FF-S-86E
AMENDMENT 4
January 16, 1991
SUPERSEDING
Amendment 3
July 9, 1990

FEDERAL SPECIFICATION
SCREW, CAP, SOCKET-HEAD

This amendment, which forms a part of FF-S-86E, dated May 29, 1987 is approved by the Commissioner, Federal Supply Service, General Services Administration, for the use of all Federal Agencies

Figure 5, View 5A

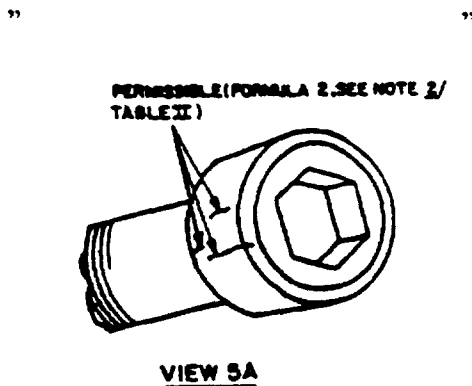
DELETE AND SUBSTITUTE:
